26 Christchurch Hill 2019/6379/P + 2020/0814/L

Delegated Report		Analysis sheet		Expiry Date:	17/02/2020
(Members Briefing)		N/A / attached		Consultation Expiry Date:	22/03/2020
Officer			Application Number(s)		
Kate Henry			1) 2019/6379/P 2) 2020/0814/L		
Application Address			Drawing Numbers		
26 Christchurch Hill London NW3 1LG			Please refer to draft decision notice		
PO 3/4	Area Team Signature	C&UD	Authorised Officer Signature		
Proposal(s)

1) Installation of rooflight on main roof; re-glaze existing windows and doors; replacement of existing boundary fence with masonry wall and railings 2) Installation of rooflight on main roof; re-glaze existing windows and doors; replacement of existing boundary fence with masonry wall and railings; internal alterations at first floor level					
Recommendation(s):		1) Grant conditional planning permission 2) Grant conditional listed building consent			
Application Type:		1) Householder Application 2) Listed building consent

Comparison of existing and proposed boundary treatment

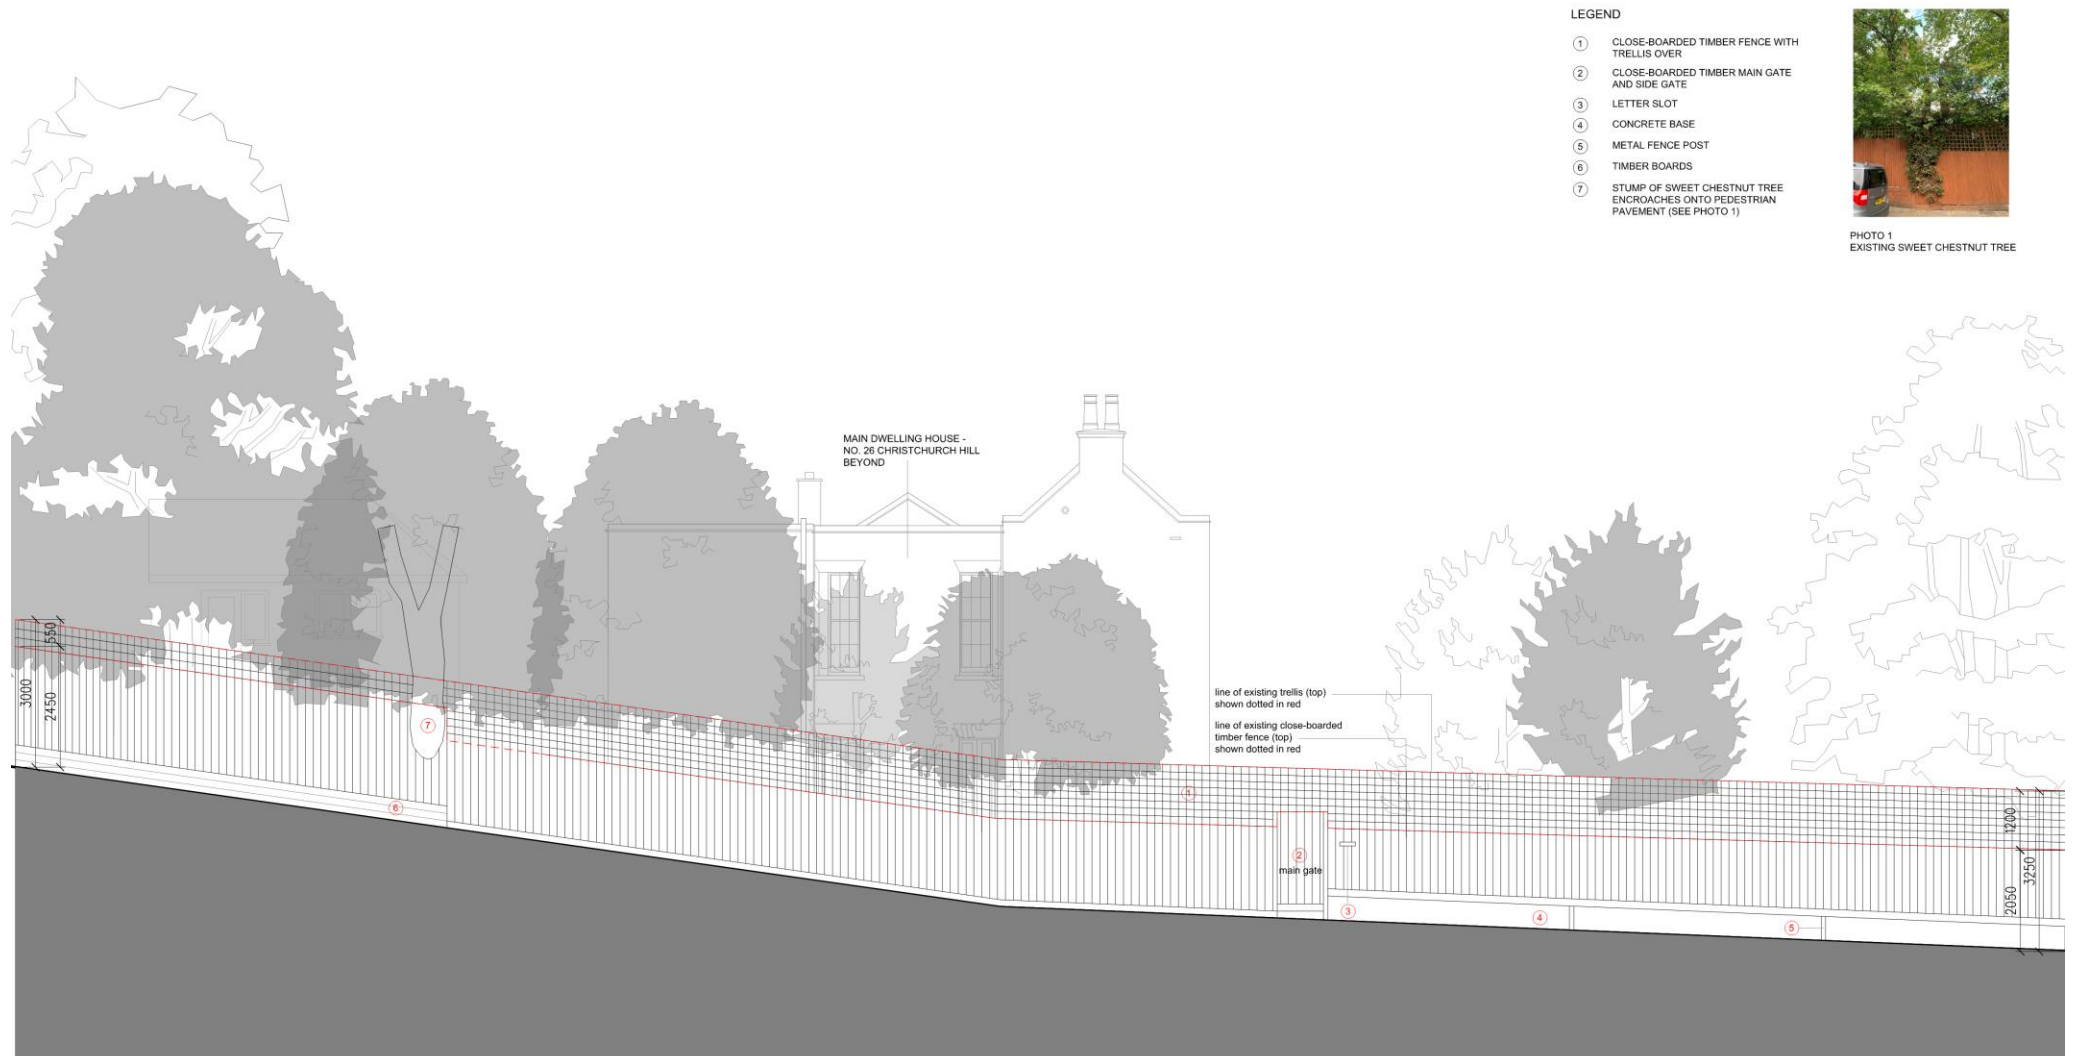
- 4.9. The proposed changes to the boundary walls are considered to be acceptable. Initially, it was proposed to replace the existing wooden fence and trellis with a solid masonry wall built to the same height as the former trellis (i.e. up to 3.3 metres in height). However, concerns were raised regarding the excessive height of the wall adjacent to the footpath and the impact on the character and appearance of the area and on users of the footpath. This is because the trellis above the existing fence is open in character and allows views into the site, whereas a solid brick wall up to 3.3 metres in height would completely block views into the site and would appear overly defensive and would also appear oppressive and overbearing to users of the adjacent footpath.

- 4.10. Officers suggested that the solid masonry wall be reduced in height to be no taller than the lintel above the existing gate on the Christchurch Hill elevation and the plans have been revised accordingly. The solid part of the replacement wall facing Christchurch Hill would measure up to 2.32 metres tall, with 0.98 metre high railings above up to the height of the existing trellis (3.3 metres); and on the Well Road elevation the solid element would measure between 1.7 metres and 2.32 metres in height (to account for changes in land levels) with 0.68 metre railings above up to the height of the existing trellis (3 metres).

- 4.11. Concerns have been raised by HNP and the Hampstead CAAC that the height of the proposed wall, as amended, would still fail to enhance the character and appearance of the area and that the new wall would be unsympathetic to the prevailing height of most street-facing walls in the area. However, as acknowledged by the Hampstead Conservation Area Statement, sub-area 2 of the conservation area contains a wide variety of building types and styles and the existing fence is of no great quality.

- 4.14. Overall, officers consider that a solid wall measuring up to 2.32 metres in height would be appropriate, particularly as the solid element would not be significantly higher (circa 0.25 metres) than the solid part of the existing wooden fence and the proposed wall represents an improvement in visual terms as the existing wooden fence and trellis are of no great quality and do not contribute positively to the character and appearance of the conservation area.

- 4.15. The metal railings above are also considered to be acceptable as they will allow views into the site, in the same way the existing trellis does. Furthermore, the applicant has noted that the front garden is on raised ground and where the boundary for No. 26 Christchurch Hill meets No. 22 (there is no No. 24), the top of the existing boundary fence is actually at the level of the raised garden and only the trellis portion of the fence is above ground level. This therefore limits the minimum height for the proposed replacement wall (i.e. the wall cannot be lower than land which it retains and the railings above must be high enough to form a secure barrier for anyone standing in the garden above the drop to the pavement).
